April 18, 2011

Subject: Comments on the Homewood Mountain Resort Ski Area Draft Environmental Impact Report

I have reviewed the January 2011 Draft Environmental Impact Report (DEIR) for the Homewood Mountain Resort Ski Area Master Plan CEP Project (HMR-CEP) for impacts associated with stormwater quality, water supplies, groundwater quality impacts, and land coverage. The 1,253-acre project area is located on the west shore of Lake Tahoe, approximately six miles south of Tahoe City in Placer County, California. The project area is bound by State Route 89 to the east, Ellis Peak to the southwest, and Blackwood Ridge to the north. The Proposed Project includes the redevelopment of the existing ski area north base facility, the residential base area to the south, and development of a mid-mountain lodge and beginner ski area.

Figure 15-15. Off-Site EIP Project Design Schematic

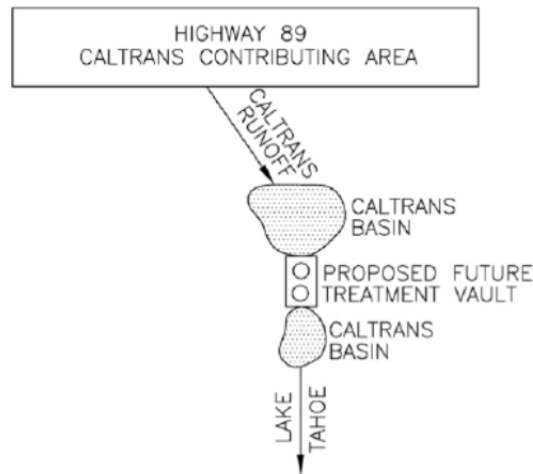
The DEIR provides no estimates of how the Contech system will work under actual field conditions with predicted 10-, 25- and 100-year events in reducing fine particulate loading to Lake Tahoe. The DEIR should be revised to include real world examples of Contech installations, preferably in the Tahoe basin, and to provide data to demonstrate effective reduction of fine particulates.

If data cannot be provided to demonstrate reduction of fine particulates, redesign of the system should be considered in a revised DEIR. The system, as proposed, is schematically presented below.

To increase the HMR-CEP effectiveness, consideration should be given in a revised DEIR to routing stormwater to an infiltration gallery after treatment by the Contechs system, in a fashion similar to the treatment train that is proposed for stormwater treatment for the project. Discharge to a basin, especially during high-flow conditions will not be as effective in reducing TSS.

Project No.:		Homewood Ski Resort	
Title:		Map of Road Status as of 1972	
Project No.:	438	Drawn By:	JAC
Approved:	MH	Date:	04.06.2011
			1

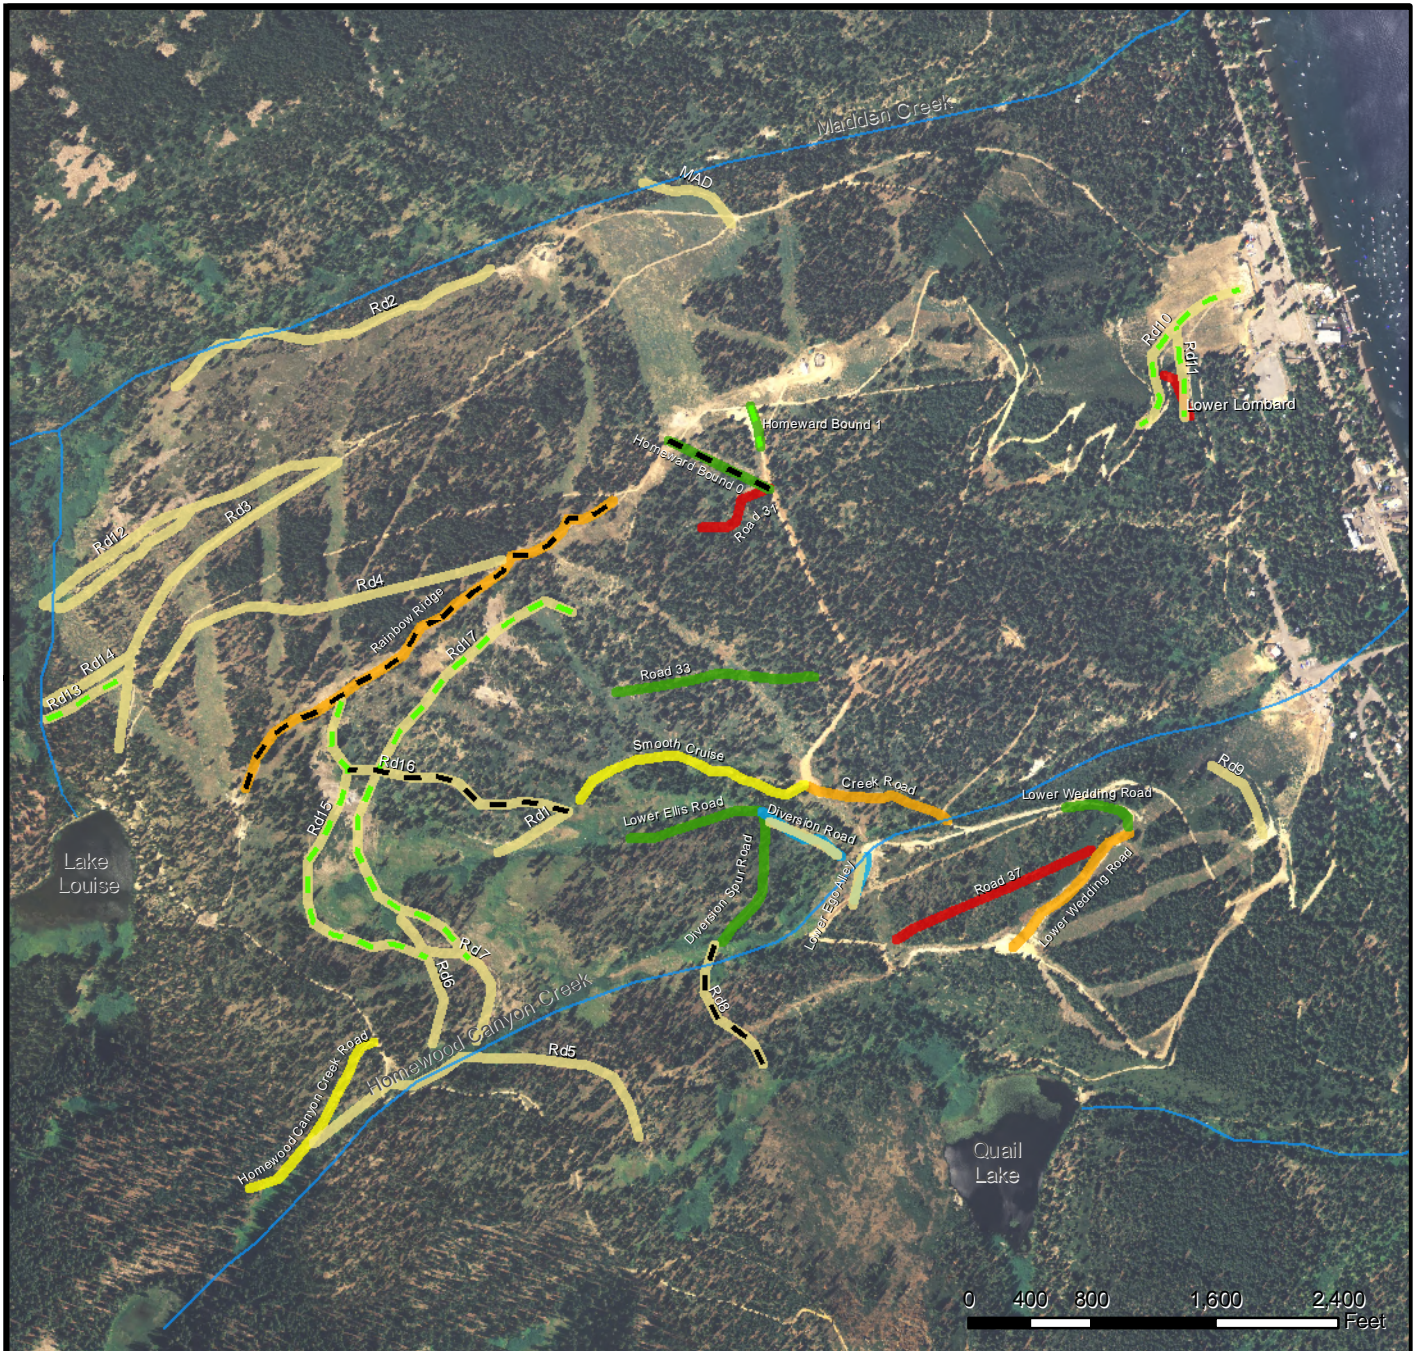
For those roads that are proposed for removal of land coverage (see DEIR, Figure 14-5), Road 8 and Road 16 were not in existence as of February 10, 1972. These roads are a combined 2400 linear feet and represent approximately 10% of the 25,000 linear feet of roadways that are proposed for restoration. If an average roadway width of 12.5 feet is used (roadway widths range from 7 to 18 feet, according to the DEIR on p. 14-20), these roadways represent 30,000 square feet of coverage.

Additionally, our analysis shows that a number of other roadways may not have been in existence as of February 10, 1972. The uncertainty stems from the dates of the photographs and the maps and the visibility of the roadways in those maps. For those roads where land coverage has been removed, our analysis shows Homeward Bound 1 may have been nonexistent in February 1972 (Figure 1).

Homeward Bound 1 is 300 feet in length and received treatment on 3,624 square feet, or about 2% of the area claimed as eligible for restoration credits. For those roads that are proposed for removal of land coverage, Road 10, Road 11, Road 15 and Road 17 may not have been in existence as of February 10, 1972. These roadways represent a combined 6600 linear feet and approximately 26% of the 25,000 linear feet of roadways identified for potential restoration.

In summary, according to our analysis, 36% of the area of the roadways where restoration has taken place is ineligible for banking because the roads were not in existence as of February 10, 1972. For those roadways that are being considered for land coverage banking, 10% were not in existence as of February 10, 1972 and 26% of the roadways identified for potential restoration may not have been in existence as of February 10, 1972. Because they were not present as of February 10, 1972, they are ineligible to be qualified as restored land coverage under provisions of the TRPA Code, Chapter 20, Land Coverage Standards.

A revised DEIR should be prepared to verify the existence of the roads of February 10, 1972 in areas already restored or in areas proposed for restoration. All roads not in existence as of that date should be eliminated from discussions regarding banking of land coverage. Instead, roads that have been restored should be included for credit for restoration of disturbed lands to meet TRPA goals.

Project No.:		Homewood Ski Resort	
Title:		2005 Orthographic Imagery and 1970-1971 Detailed Site Investigations Map, North Parking Lot	
Project No.:	438	Drawn By:	JAC
Approved:	MH	Date:	04.13.2011
			2

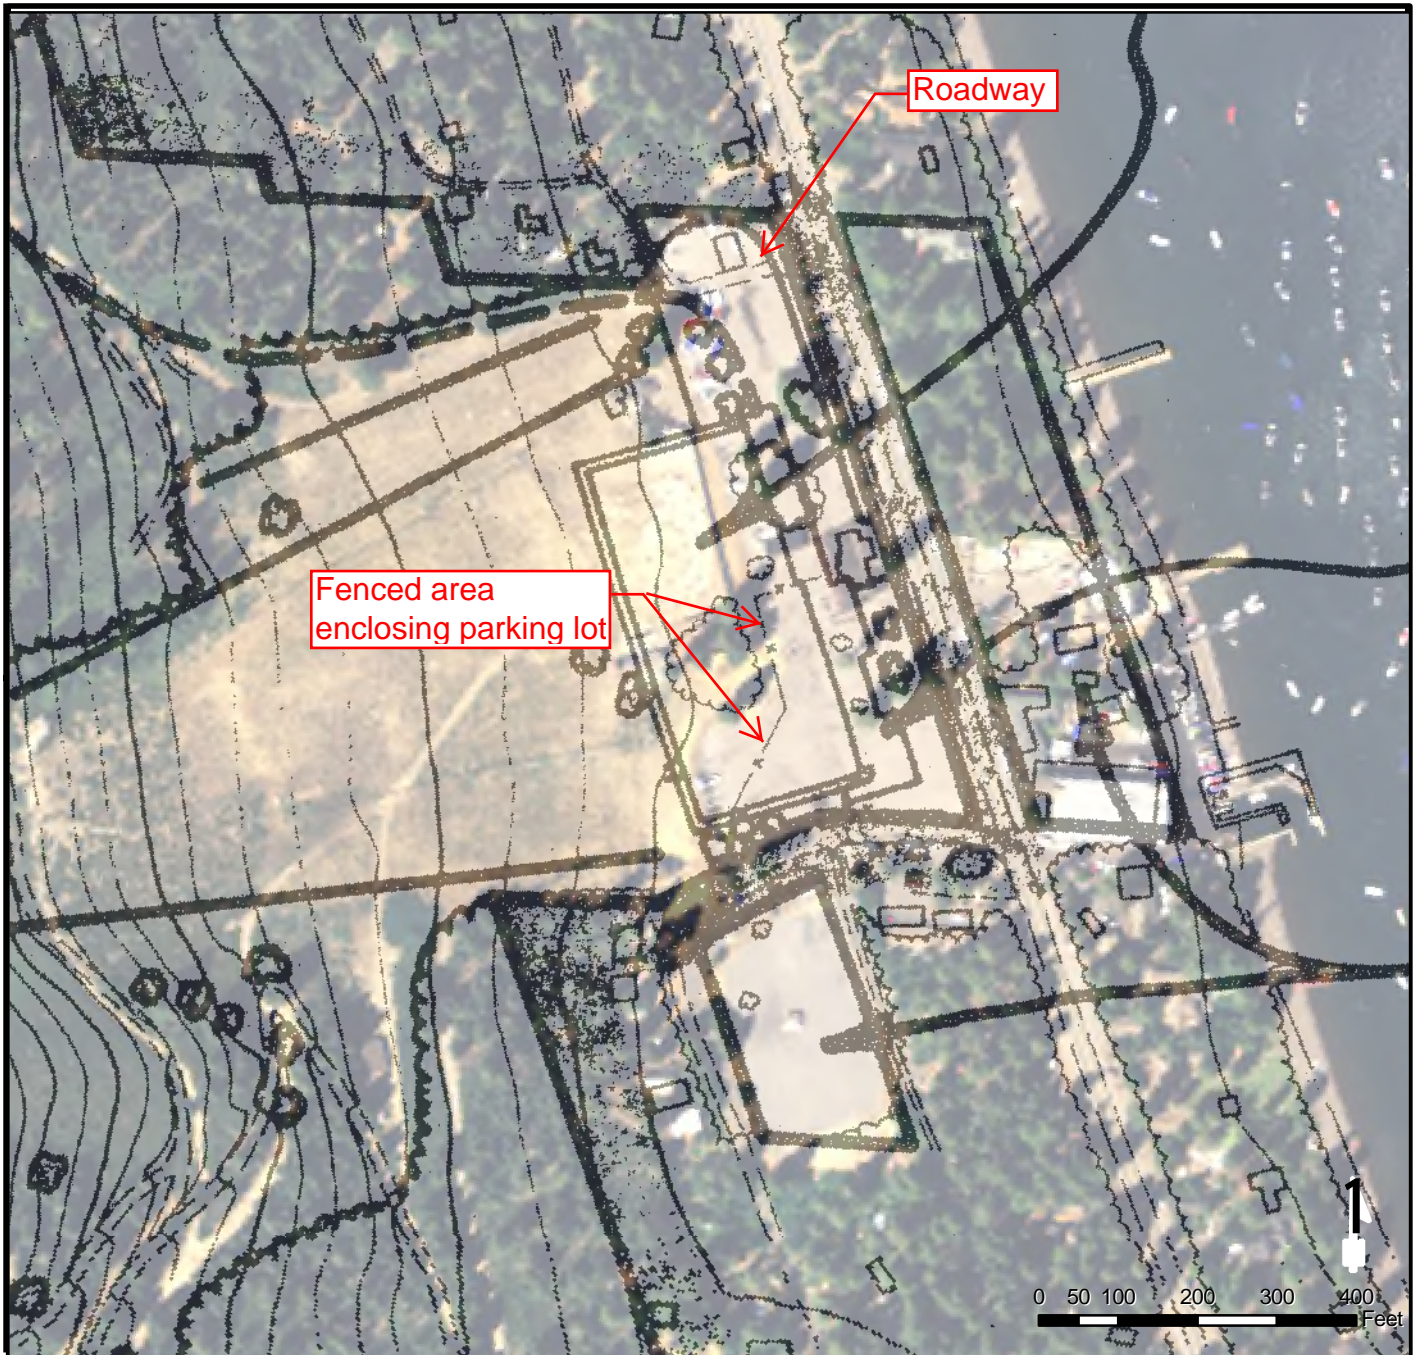
Additionally, we have conducted an analysis of the North Base parking lot and have determined that the majority of the parking lot was not in existence as of February 10, 1972. Figure 2 shows an overlay of a map prepared on the basis of conditions that existed as of November 1971 (Attachment 2), arguably the same conditions that would have existed on February 10, 1972 given that the winter season would have prevented any further development.

Figure 2 depicts two features that indicate the parking lot was not in existence in February 1972.

1. A roadway in the northern area of what is now the parking lot is shown to extend east/west to join with the highway. If the lot was in existence at the time, the roadway would be shown to empty into a parking area.

2. An area that would appear to be fenced extends west and south of the lodge toward the southern boundary of the site and to the highway to the east. This appears to be the extent of the parking area as of February 10, 1972.

The fenced area represents 29% of the area of the parking lot that was in existence as of 2005 and that is currently in existence. Therefore, 71% was not in existence as of February 10, 1972 and cannot be claimed as existing coverage.
